Federal Recall Information

19PBE

Safety Recall – Back of Sleeper Reflective Conspicuity Tape Location

11/4/2019

Figure 1

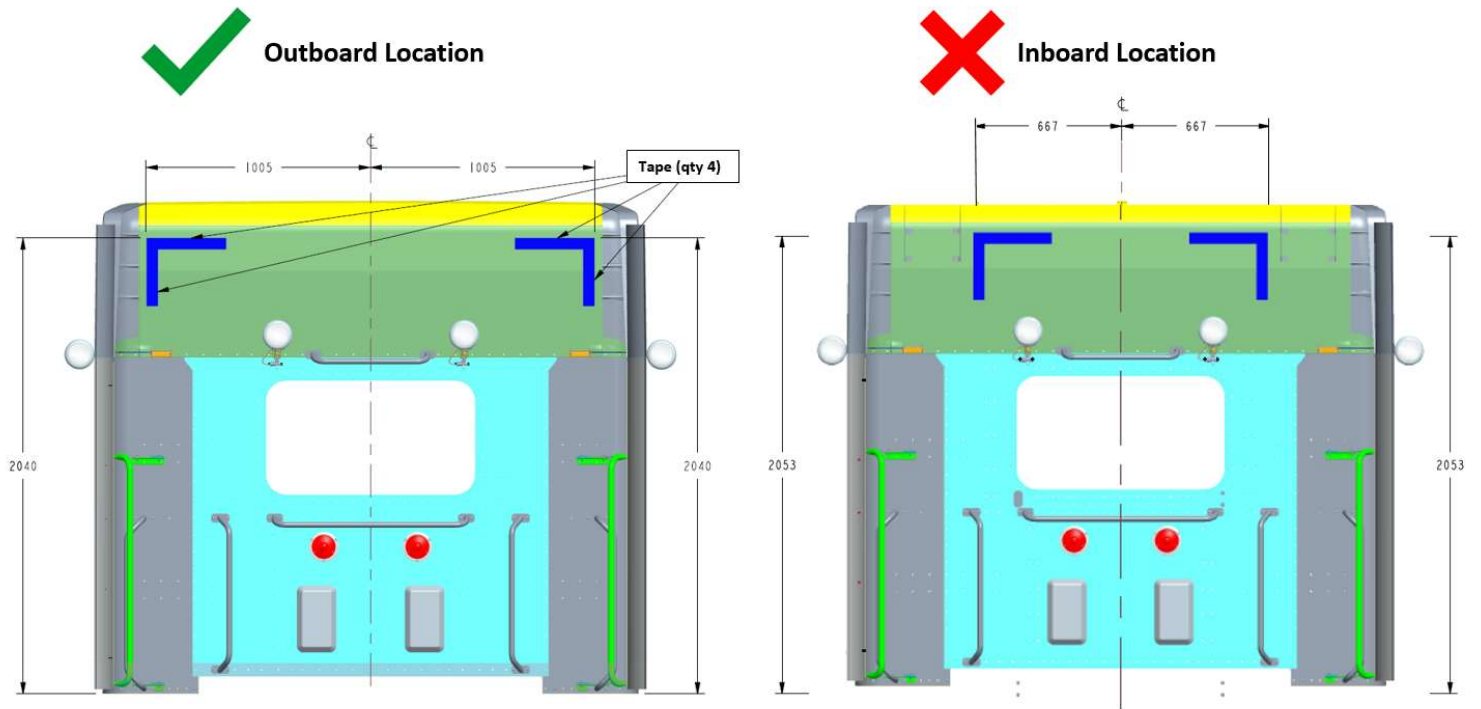
Peterbilt Motors Company has determined that a regulatory non-compliance, may exist in certain model 579 vehicles manufactured between 8/26/2019 and 9/12/2019. On certain trucks, the reflective conspicuity tape on the back wall of the sleeper box was installed in incorrect locations. FMVSS 108 Section S8 2.4.2 regulations require the conspicuity tape to be placed in specific areas. A truck that does not have properly placed conspicuity tape may be less visible to others and could create an increased risk of a crash. Vehicles operating without a trailer may be cited for incorrect tape location and fail an annual truck inspection.

1. Refer to Figure 1 and inspect the location of the Reflective Conspicuity Tape.
2. If the tape is located in the inboard location, continue to the next step. Removal of the tape in the inboard location is not required. If the tape is removed, use an adhesive cleaner that is appropriate for use on painted surfaces to remove the tape residue.
3. Clean the new installation surface and install the new tape in the outboard location as shown in Figure 1.
